WILLIAMSON COUNTY, TEXAS

CHANGE ORDER NUMBER: 2

FM3349 at US 79 Williamson County Project No. 22IFB139

Change Order No. 2

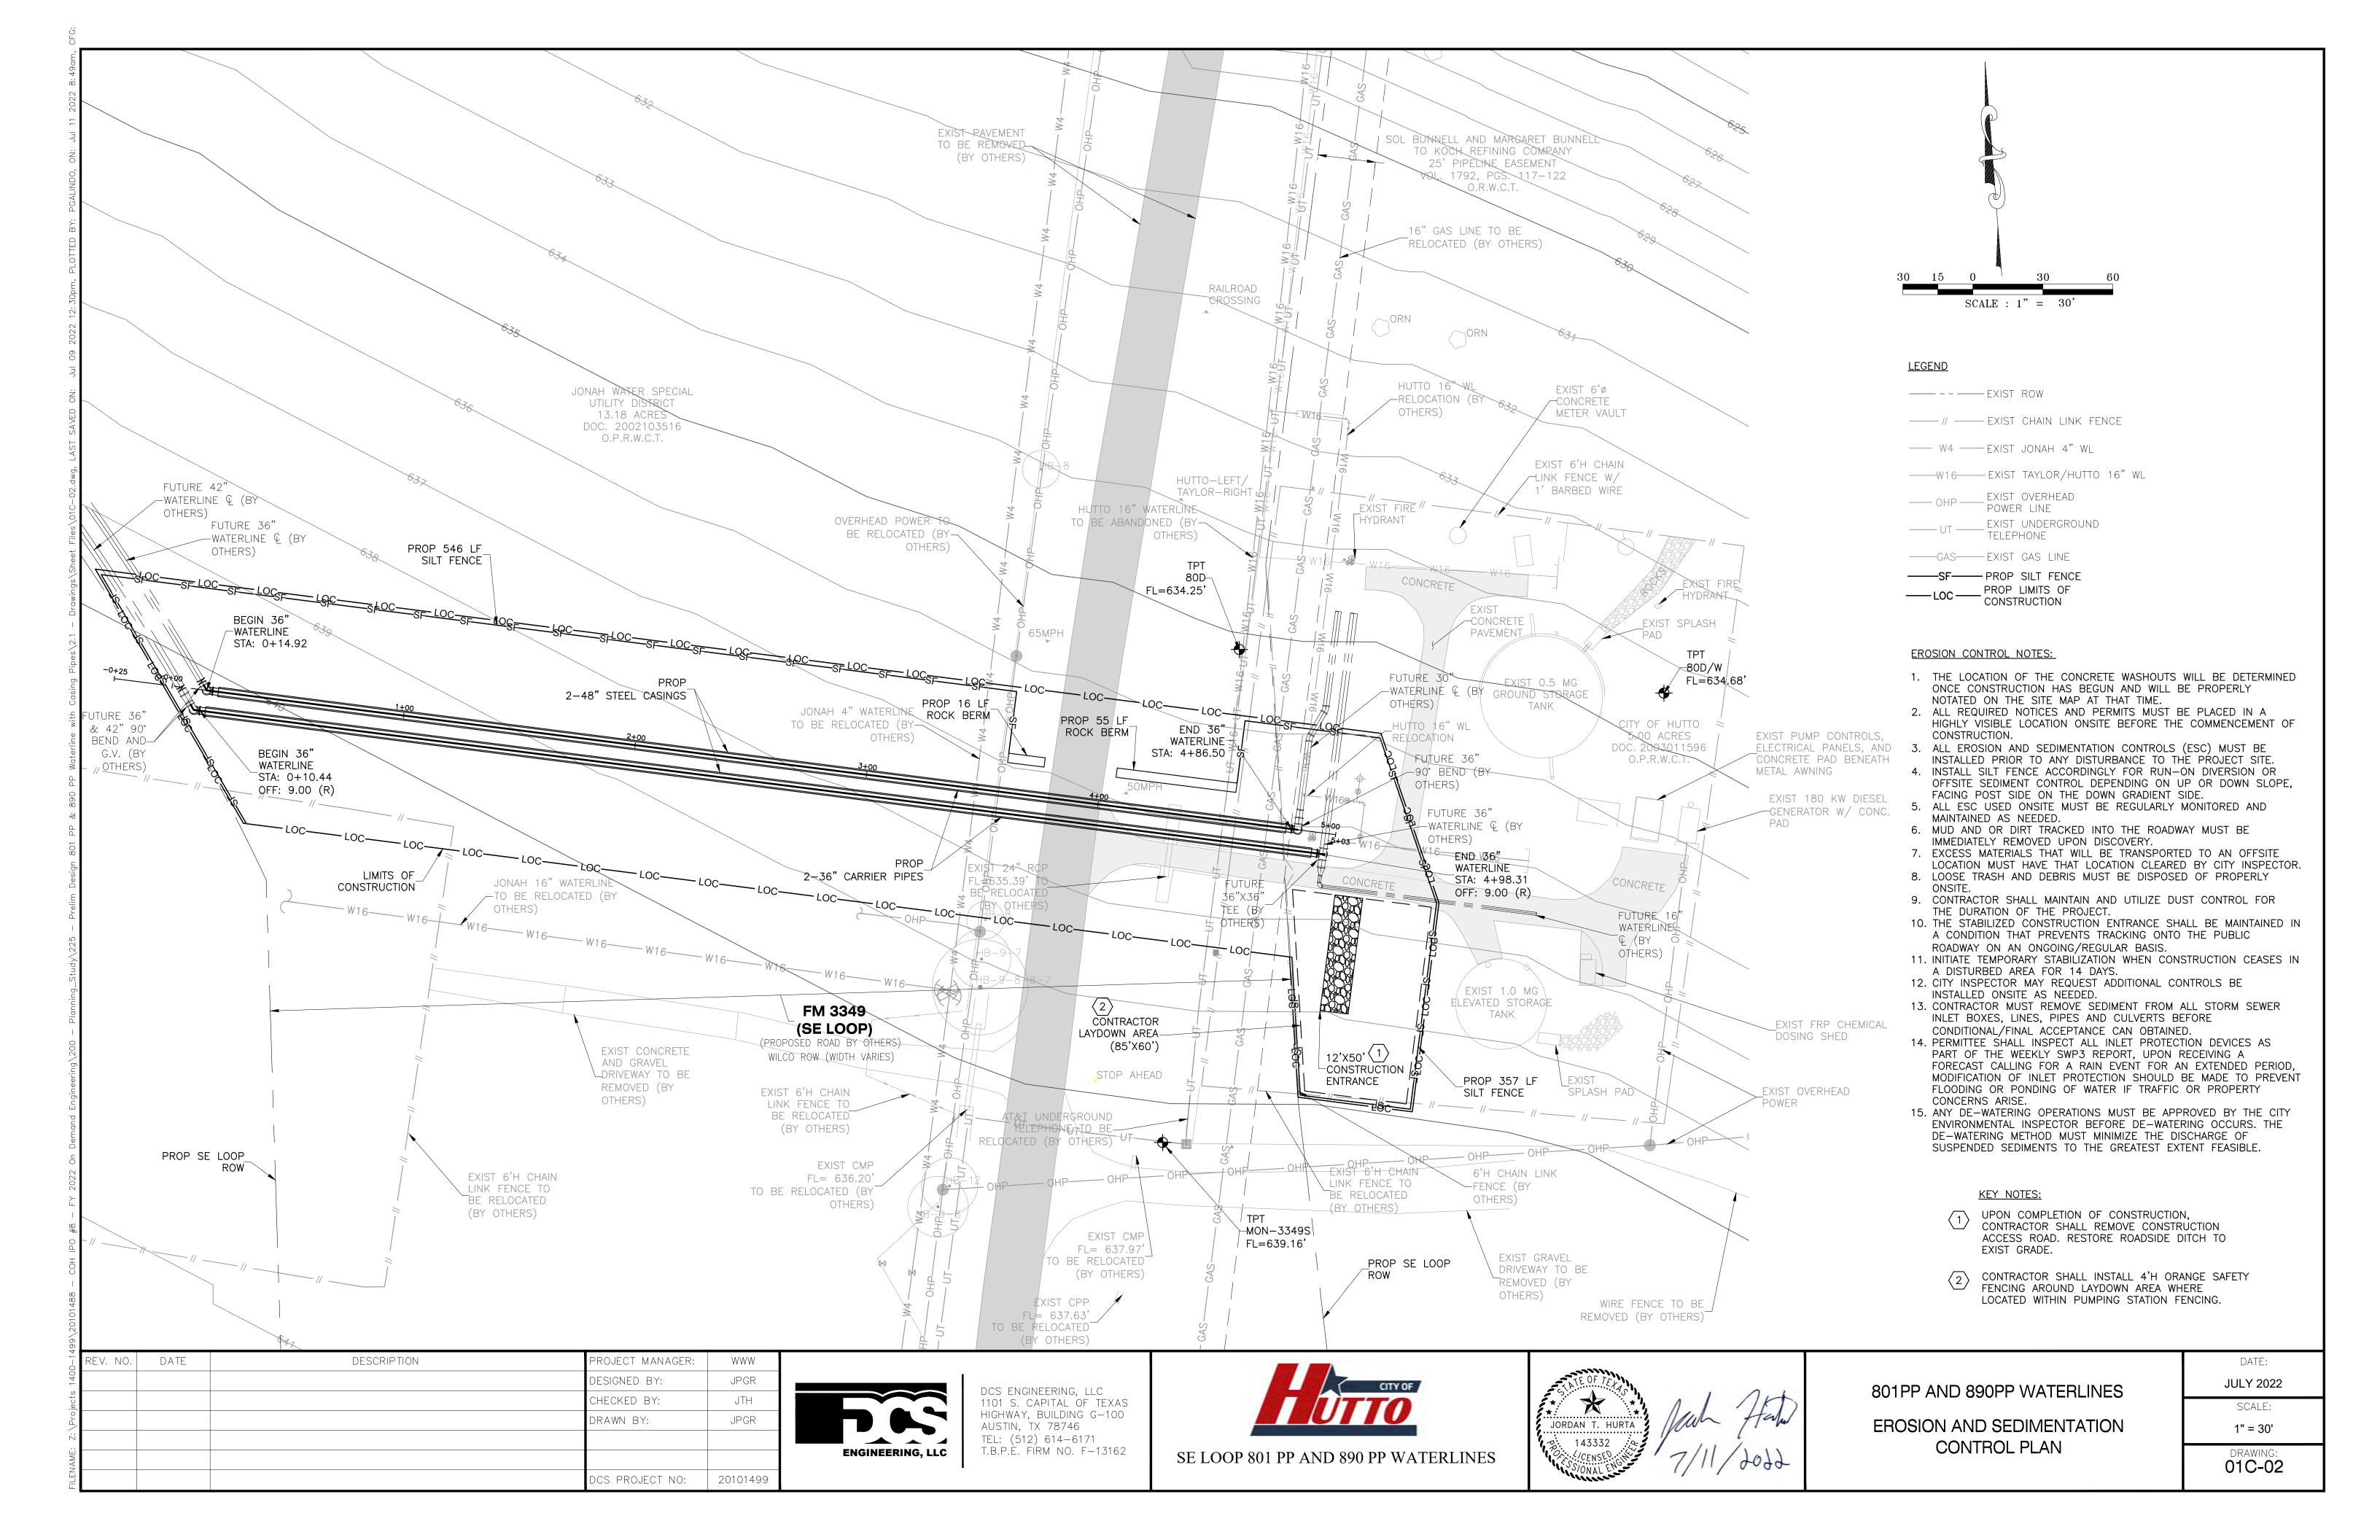
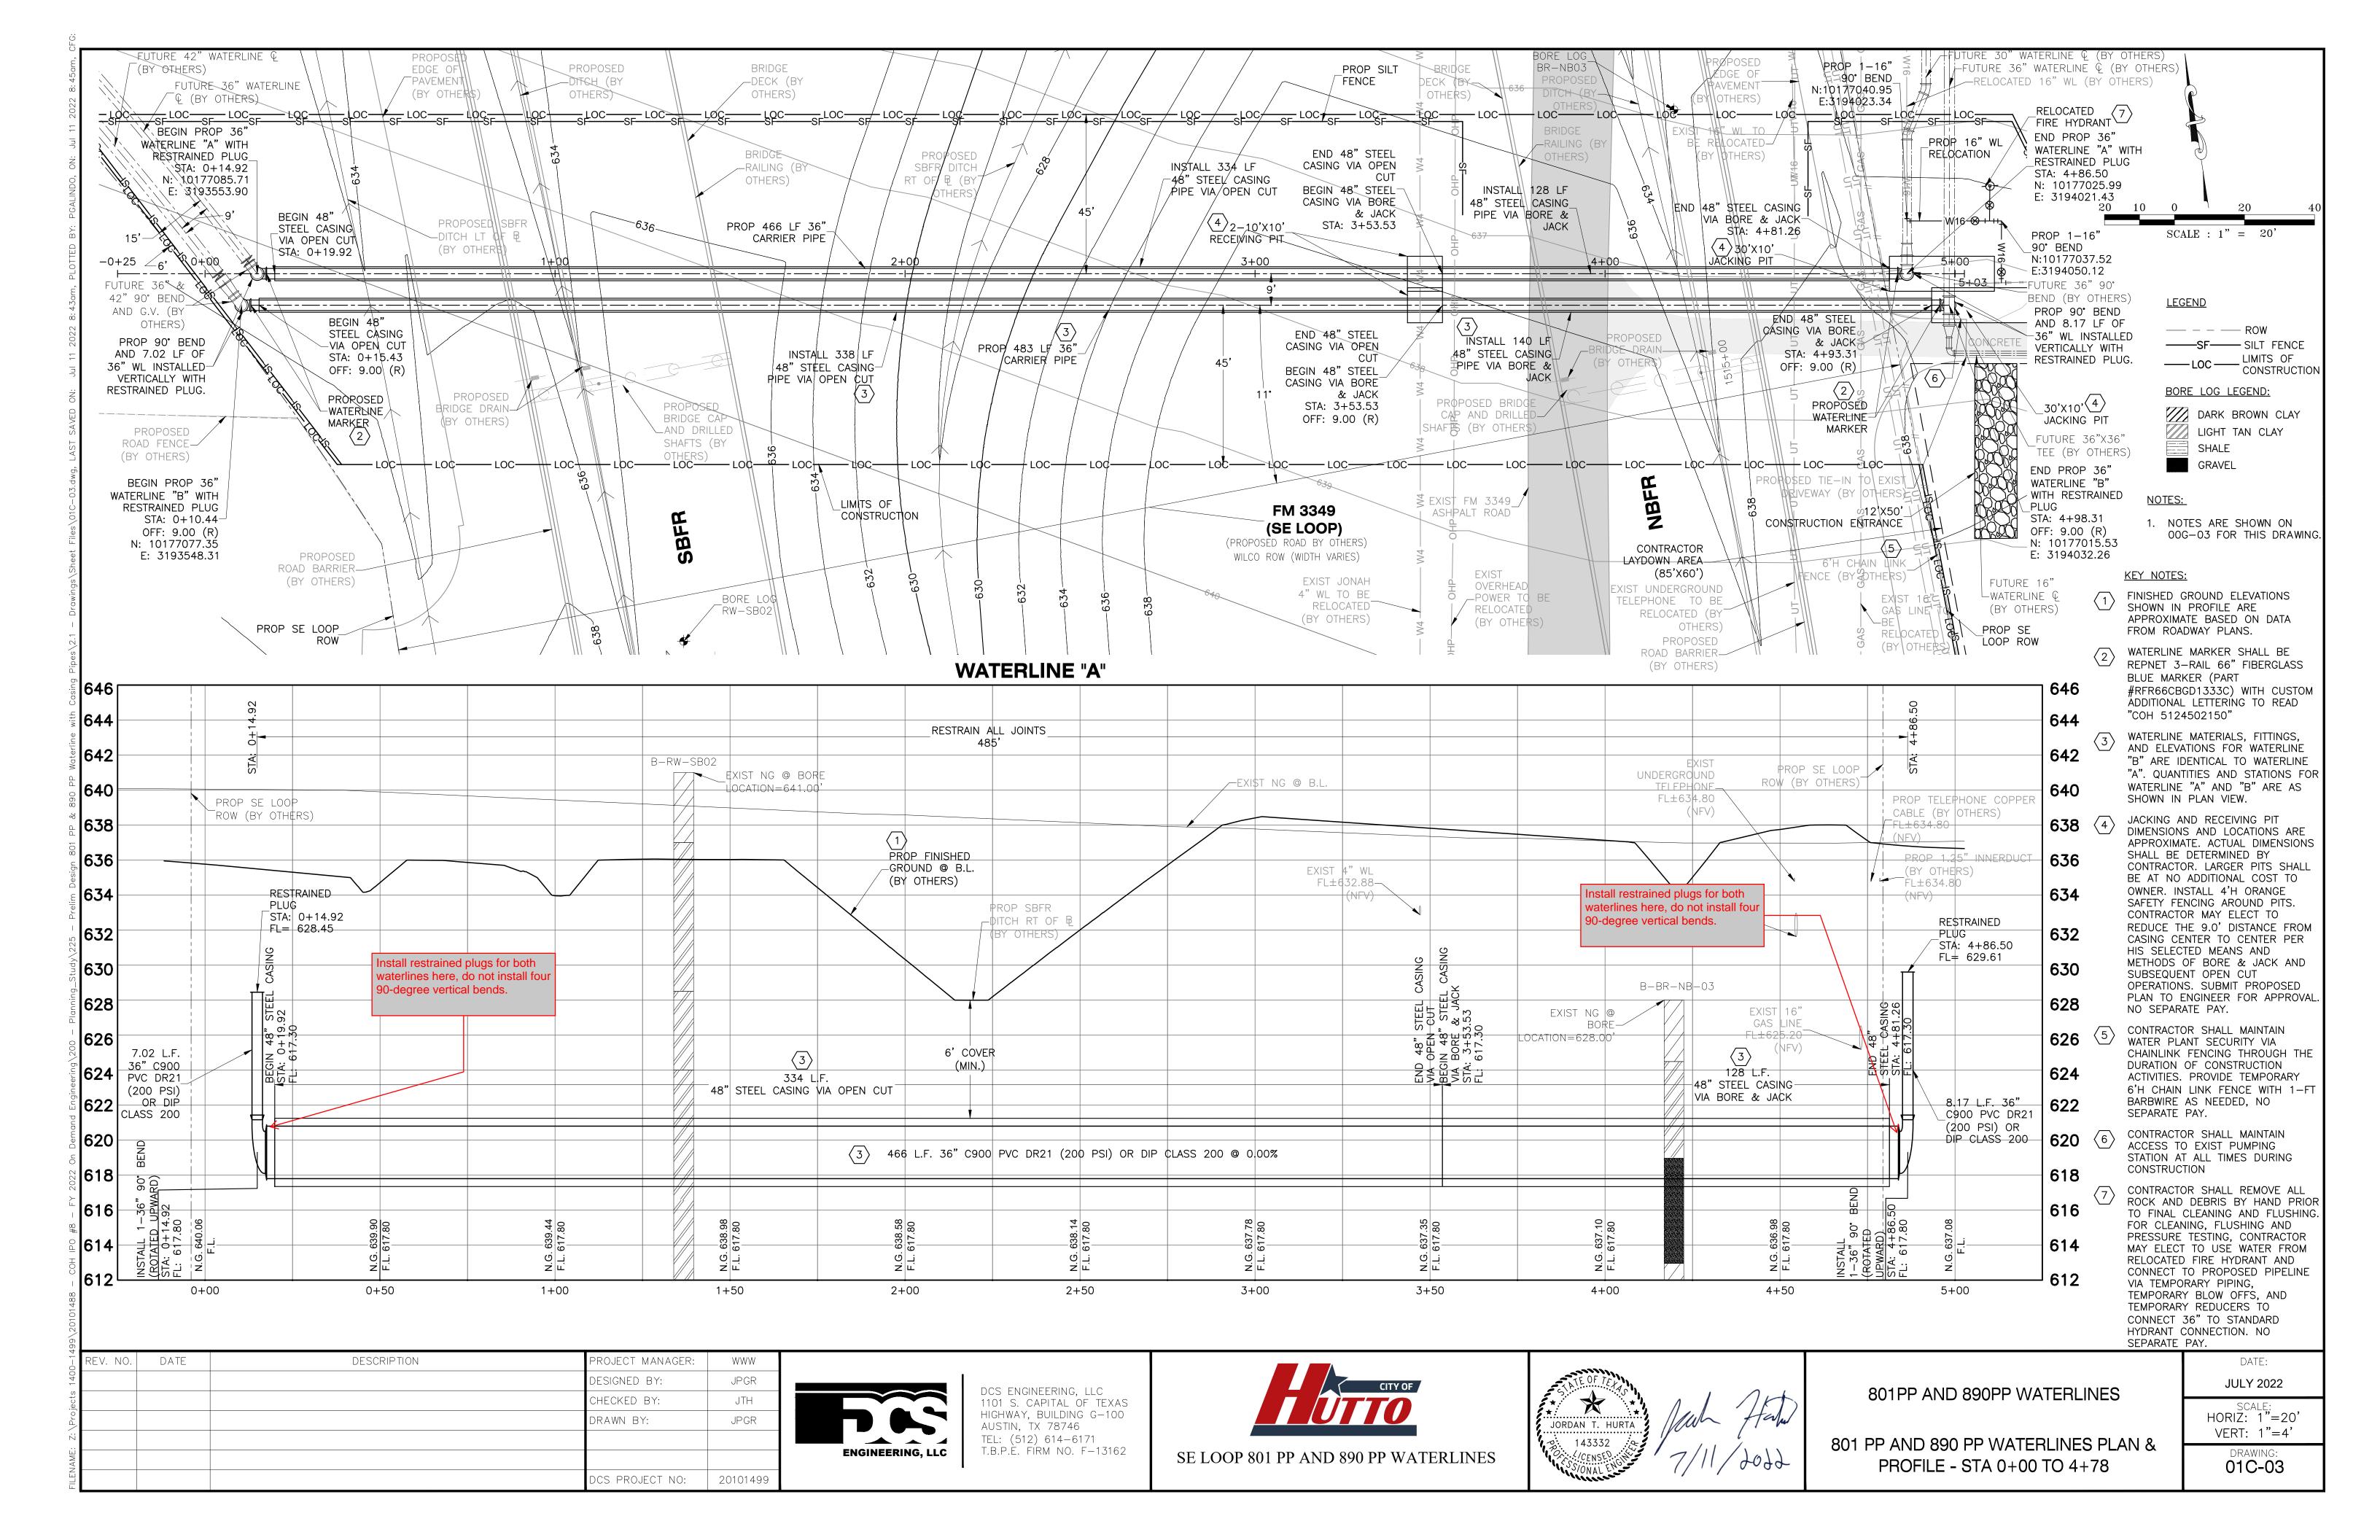
The original bid item 36-inch Ductile Iron Pipe has long lead time of material procurement and is not readily available. Contractor proposed two options with shorter lead time to the City of Hutto as alternatives. City of Hutto has approved option 2, which is 36-inch PVC DR 18 pipe as an alternative with \$82,000 increase in cost to the current item and allows contractor to procure material faster. The cost of this material change is 100% reimbursable by the City of Hutto.

Following is summary of new items required for this Change Order.

ITEM	DESCRIPTION	QTY	UNIT
W1.17.G.1	Furnish and install 36" PVC Pipe Carrier Pipe DR 18 including excavation, ground and surface water dewatering, embedment, backfill, metallic underground warning tape, adaptors, couplings, joint restraints, polyethylene wrap, surface restoration, disposal of excess material, incidental work not covered by other bid items, 3/8" F bedding and backfill, and appurtenances, Complete in Place.	964	LF
